Clio II

11 MODIFICATION OF THE TOP DEAD CENTRE PIN Mot. 1489

Basic manual:
Technical Note 3069A

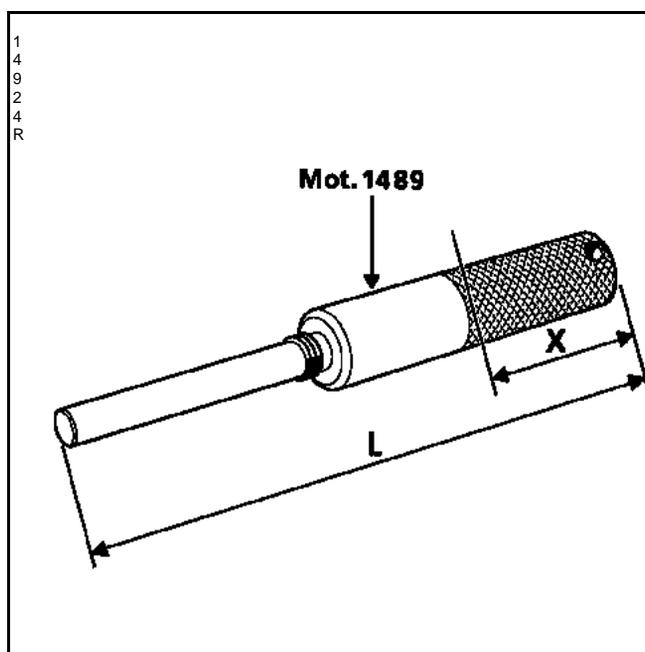
To fit pin **Mot. 1489** without removing the fan assembly, you must cut it to dimension **X = 45 mm (L = 169.5 mm)**.
